Appendix B

Public Comments and SCDES Response to Comments

CSXT Bramlett Road Site (aka Duke Power Manufactured Gas Plant) South Carolina Department of Environmental Services ("SCDES") Preferred Cleanup Plan

Proposed Plan Comments CSXT Bramlett Road Site Greenville, South Carolina

Figure 3. Location of monitoring of soil and surface water and sediment sampling on Site. Notice "insert box" of brown dense sediment Sampling locations and hydraulic gradient distance to the Reedy River of approximately 700 ft and sediment sampling along the Parcel 4 ditch. (Figure from Aquilogic.)

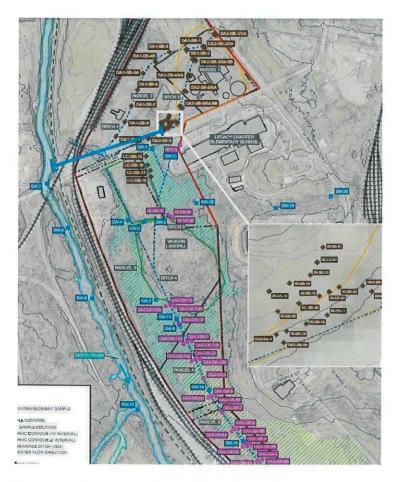
- 2a. Naphthalene Sediment Sample [$C_{10}H_8$; $log_{kow} = 3.36$], another *PAH*. This contaminant was detected in **sediment** sample **DA4-SB-7** at a concentration of **58.6** mg/kg which is greater than the regulatory standard. (See Figure 3.)

Figure 5. Shallow Zone Groundwater Potentiometric Surface Map with Monitoring Wells (Figure from aquilogic Sept. 26, 2022).

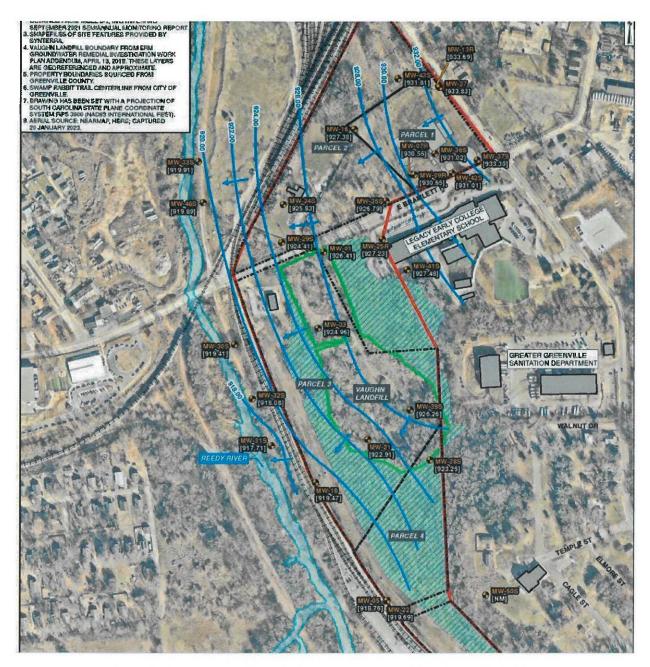
- 3a. Benzene [C_6H_6 ; $log_{Kow} = 2.13$]. Monitoring results for the shallow groundwater aquifer for well MW-1 is 26.5 µg/L collected on Sept. 27, 2022, at groundwater location of 926.4 ft NAVD. (See Figure 5.)

Figure 6. Transition Zone Groundwater Potentiometric Surface Map. (Figure from aquilogic Sept. 26, 2022.)

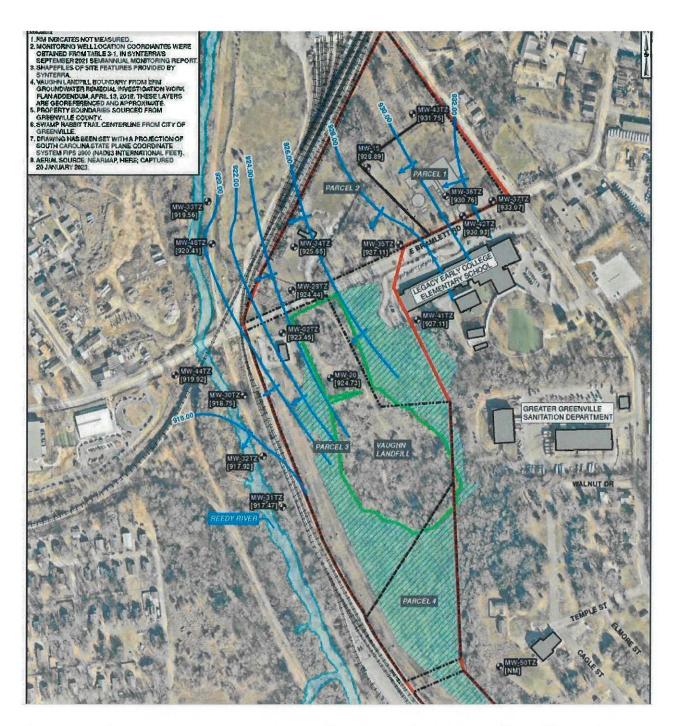
- 2b. Naphthalene Transition Zone Groundwater Sample. This contaminant was detected in sample collected Sept 27, 2022 at a concentration of 7220 μg/L in groundwater well MS-29TZ, located approximately 700 ft downgradient of the former MGP operation. Even though this well is located in the geologic "Transition Zone", the groundwater table is nevertheless relatively shallow (924.4 ft NAVD) and therefore of concern. (See Figure 6).

- 3b. Benzene Transition Zone Groundwater Sample. The contaminant was detected in sample collected Sept. 27, 2022 at a concentration of 1950 μg/L from transition well MW-29TZ, groundwater elevation 924.4 ft NAVD. (See Figure 6.)

Referring to **Figure 6**, taking the elevation from the potentiometric map for the groundwater from **monitoring well MS-29TZ** to the down-gradient surface elevation of the Reedy River, yields a hydraulic head differential of:
